21154 PCI-to-PCI Bridge

Specification Update

July 2004

Figure 1. S_Clock Multiplexer Workaround Circuit for Errata 6.

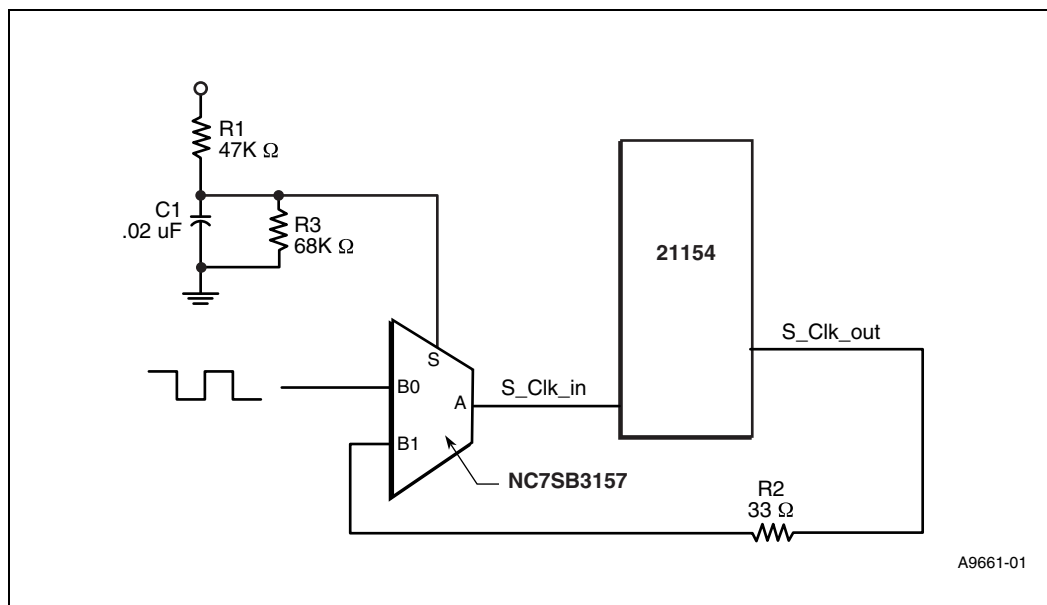
6. Secondary Clocks Outputs s_clk_o<9:0> May Not Start-up Properly Under Some Conditions

Problem: This problem has been found on the 21154AC and 21154BC. Under repeated and frequent power cycling, the secondary clock circuits may not power up in the proper state, resulting in the device not coming out of reset after power up.

Implication: In a system with a 21154AC or 21154BC that has one of its s_clk_o<9:0> outputs fed back to provide the s_clk, it is possible that the s_clk_o<9:0> output clocks will be driven and remain low, keeping s_rst_l asserted, during system power up.

1. [Figure 1](#) illustrates the first recommendation - a circuit where an on-board pulse source is gated via the B0 input of the multiplexer to the S_Clock_in pin of the 21150.

At time 0, the S input of the multiplexer is low, allowing pulses from the on-board pulse source, connected to the B0 input, to be provided to the 21150 S_Clk input pin. When the time determined by the R/C network is satisfied, the S input pin will be in a logic High state. The multiplexer will then shut off the input pulse from S0 and will direct the S_Clock_out pulses via the B1 multiplexer input, into S_Clock_in

The values used for the R/C network should be selected to allow a minimum of 2 pulses to be delivered to the 21150 after Vdd has reached 3.0V at a frequency not to exceed the appropriate PCI component. i.e. 30 ns for a 33Mhz bridge. These values should be chosen based on the rise time of the power supply and the frequency of the on board pulse source. The values given for R1, R3, and C1 are for example purposes only.

Note: The NC7SB3157 2:1 Multiplexer / Demultiplexer Bus Switch used in this example has a maximum propagation delay of 800ps that should be taken into consideration when matching trace lengths of the clock lines to avoid introducing excessive skew in the clocks. All S_Clock etch lengths must be matched to within 2ns @ 33Mhz or 1ns @ 66Mhz. The addition of this circuit requires that the etch length for the S_clock_in signal be reduced to compensate for the 800ps delay.

Figure 2. Recommended Circuit for a Tristable Buffer

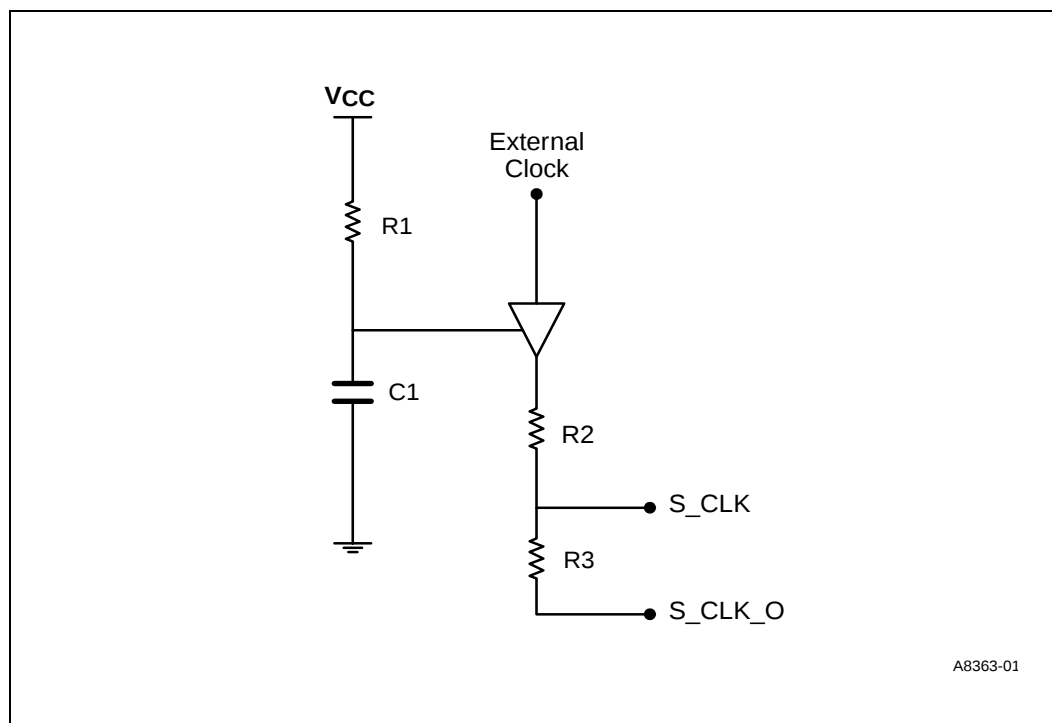
2. In the second recommendation, to guarantee the proper initialization of the **s_clk** circuits, the addition of an external circuit that provides a minimum of two transitions on the **s_clk** input during the power-up ramp is necessary. This can be done using a solution that drives an external clock onto the **s_clk** input while 3.3V Vcc is ramping during power up.

Figure 2 illustrates the use of a tristable buffer to provide multiple pulses to the **s_clk** input. The Vcc ramp rate and R1,C1 time constant determine the duration and amplitude of the pulses generated during power up. The R2-R3 values are chosen based on applicable board etch impedance-matching requirements.

The following should be considered in calculating the R1,C1 time constant:

- Make the time constant of the circuit as short as possible, while still ensuring that a minimum of two pulses are generated during the Vcc ramp.
- Phase delay between **s_clk_o** and the external clock should be minimized.
- Matching the external clock and **s_clk_o** frequencies to reduce contention.
- Laboratory experiments using **p_clk** as the external clock and a R1C1 time constant between 40 and 60 percent of the Vcc ramp have been successful using this configuration. However the use of **p_clk** as the external clock violates the PCI bus specification for loading of the primary clock.

Figure 6. Removal of Pull-Down Resistor for JTAG Testing

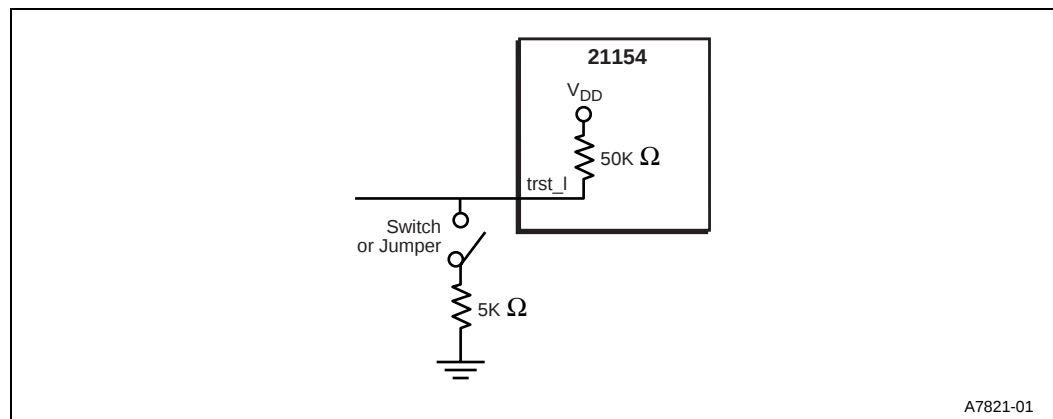
9. Section 6.3.1, Signal trst_l Pull-Down Resistor, New Section

A 5 K Ω pull-down resistor is required on trst_l for normal PCI-to-PCI bridge operation. However, some JTAG test results may be inconclusive if the 5 K Ω resistor remains in the circuit. To obtain accurate JTAG results, Intel recommends one of the following solutions:

- Verify that the JTAG test equipment, after driving trst_l low to reset the TAP controller, constantly drives trst_l high during JTAG tests. If this signal is not constantly driven high, the 5 K Ω resistor will pull the signal to a low state.
- Remove the 5 K Ω resistor during JTAG tests. This resistor must be installed during normal PCI-to-PCI bridge operation.
- Design external circuits with a switch or jumper to isolate the 5 K Ω resistor during JTAG tests (see Figure 6). This switch must enable the resistor during normal PCI-to-PCI bridge operation.

Figure 19 Example of GPIO Clock Mask Implementation on the System Board

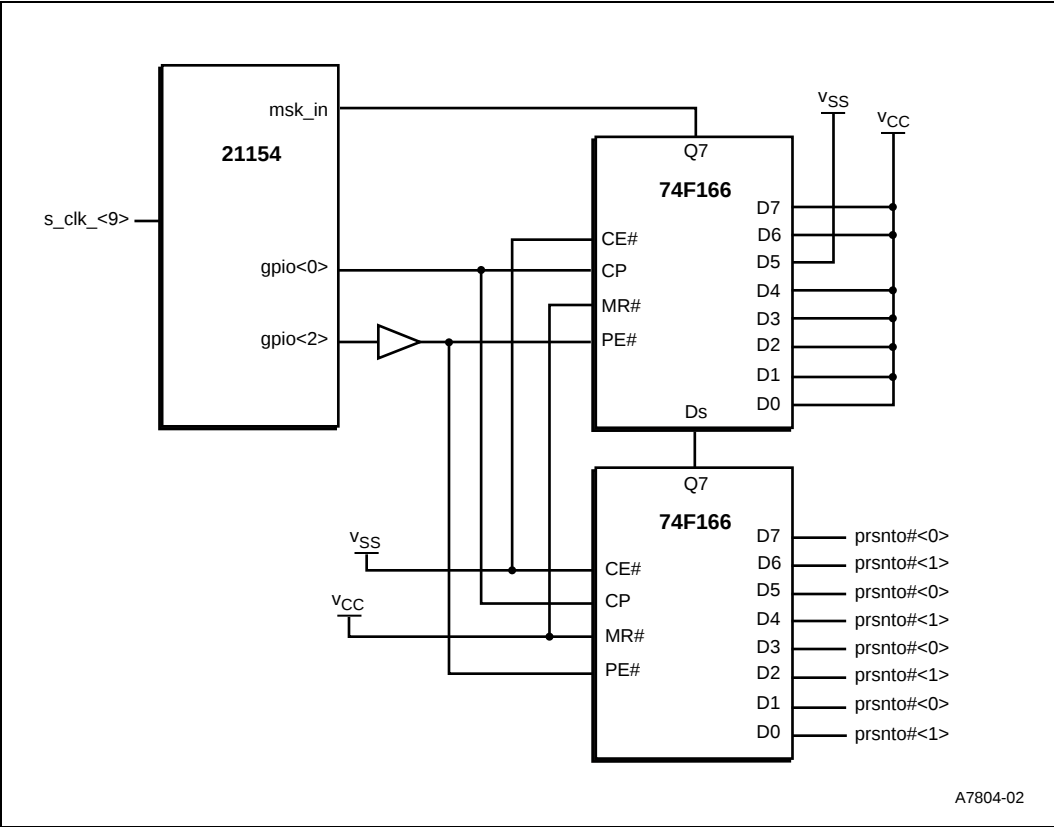
12. Section 10.2, Secondary Clock Control, Figure 19

This figure now appears as follows:

Figure 20. Clock Mask and Load Shift Timing

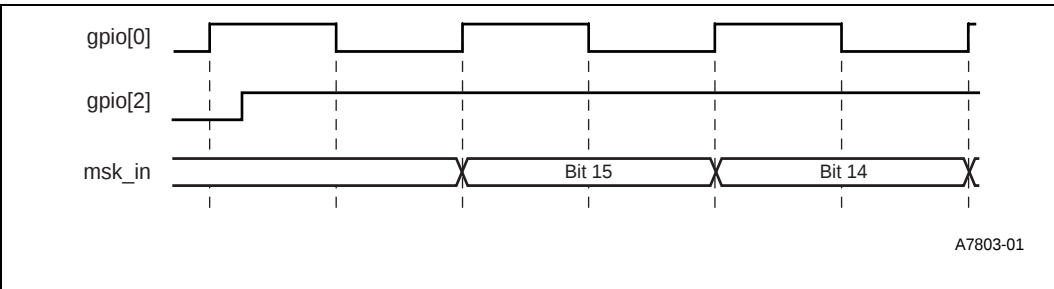
13. Section 10.2, Secondary Clock Control, Figure 20

This figure now appears as follows:

Figure 21. Clock Mask and Load Shift Timing

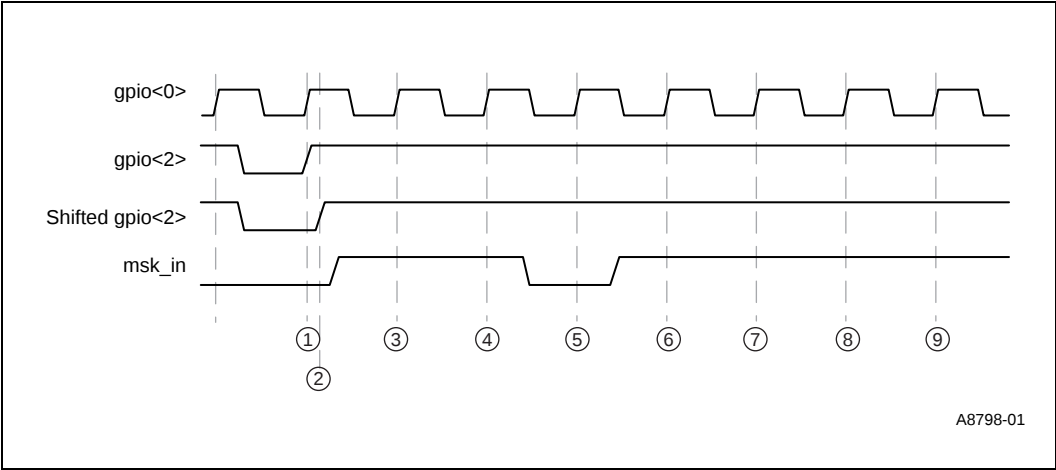
15. Section 10.2.1, Mask and Load Shift Timing Events for 66 MHz Operation

The following list provides the timing sequence for 66 MHz operation for an example circuit as shown in [Figure 19](#) and the timing diagram in [Figure 21](#).

1. The **gpio<2>** original coming from the 21154 does not provide 3ns setup time needed to provide the parallel load enable **PE#** of the 74F166.
2. The shifted **gpio<2>** is delayed by ~9ns to provide ample setup time to enable the parallel of the shift register connected to pin 15 of the 74F166.
3. Bit 15 input **D6** of the shift register is pulled high, to Vcc.
4. Bit 14 input **D7** is pulled high, to Vcc. These signals are not used internally in the 21154.
5. Bit 13 **s_clk_o<9>** is a feedback to the 21154 **s_clk_o** input. To enable **s_clk_o<9>** in all cases the **D5** input of the shift register is grounded, to Vss.
6. Bit 12 **s_clk_o<8>** is disabled.
7. Bit 11 **s_clk_o<7>** is disabled.
8. Bit 10 **s_clk_o<6>** is disabled.
9. Bit 9 **s_clk_o<5>** is disabled.

Figure 3 Example of GPIO Clock Mask Implementation on the System Board

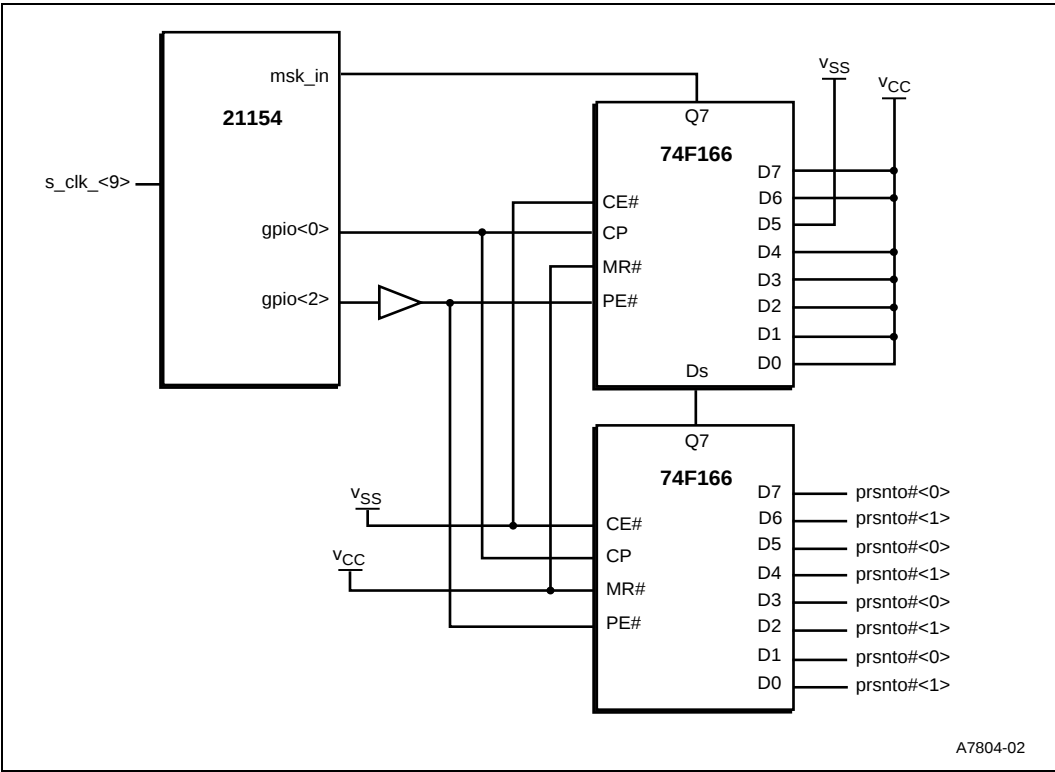
18. Section 4.4.1, Serial Clock Mask Shift, Figure 3

Figure 3 has been updated as follows:

Figure 4. Clock Mask Load and Shift Timing

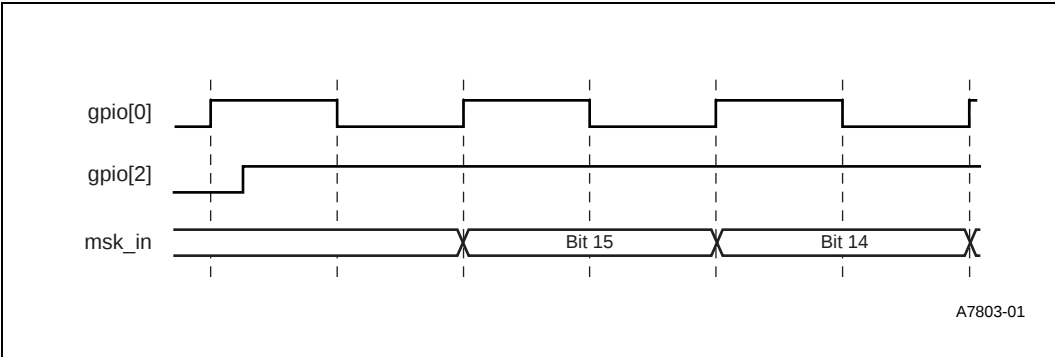
19. Section 4.4.1, Serial Clock Mask Shift, Figure 4

Figure 4 now appears as follows:
